PLANNING, ZONING, & BUILDING DEPARTMENT  
PZ&B Staff Memorandum: Landmarks Preservation Commission

SUBJECT: HSB-22-017 (ZON-23-005) 128 SEABREEZE AVE (COMBO)

MEETING: MARCH 22, 2023

The applicant has submitted plans “128 SEABREEZE RENOVATION” as prepared by LaBerge & Menard, Inc., dated March 01, 2023.

Figure 2: Variance Diagram

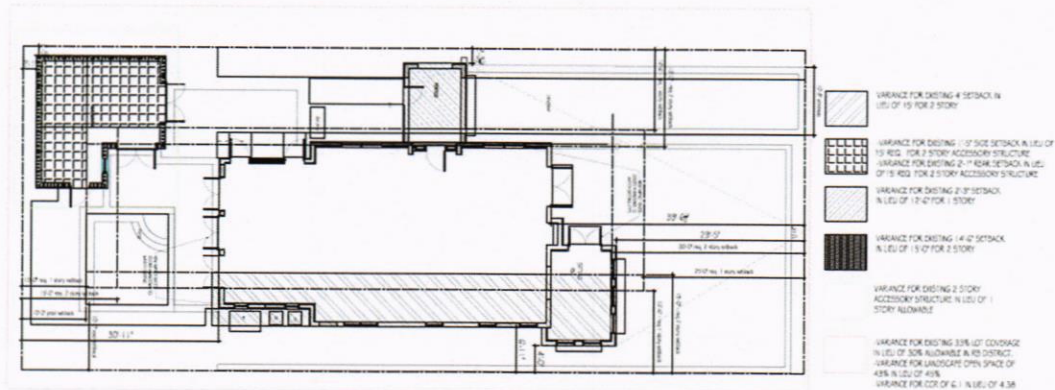
- Variance 5: Sec. 134-893(b)(7) a.: A variance for a reduced one-story west side yard setback of 2'-3½" in lieu of the 12'-6" required for the one-story portion of the primary residence.

- Variance 6: Sec. 134-893(b)(7) b.: A variance for a reduced two-story west side yard setback of 14.6' in lieu of the 15' required for the two-story portion of the primary residence.

- Variance 7: Sec. 134-893(b)(7) b.: A variance for a reduced east side yard setback of 4' in lieu of the 15' required for the two-story residence.

- Variance 8: Sec. 134-893(b)(7) b.: A variance for a reduced west side yard setback of 1'-5" in lieu of the 15' required for a two-story accessory structure.

- Variance 9: Sec. 134-893(b)(9) b.: A variance for a reduced rear yard setback of 2'-1" in lieu of the 15' required for a two-story accessory structure.
